SERVICE INFORMATION LETTER NO. 0142

Revision 1

1. SUBJECT: New Tail Rotor Assembly Bumpers

2. MODELS: F28C, 280C, F28F, 280F, and 280FX

Figure 1

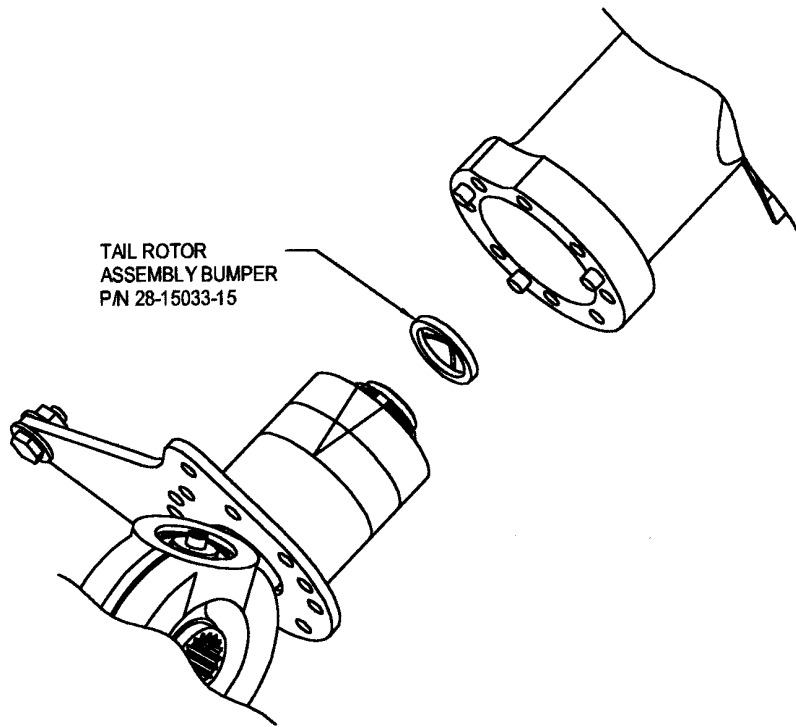
B. Replace the 28-15033-13 bumpers with the new 28-15033-15 bumpers anytime the tail rotor assembly is disassembled (Refer to Figure 1). Replace the tail rotor bumpers using the procedures found in the applicable maintenance manual for the helicopter with the exception that the bumpers are not glued onto the end of the spindle.
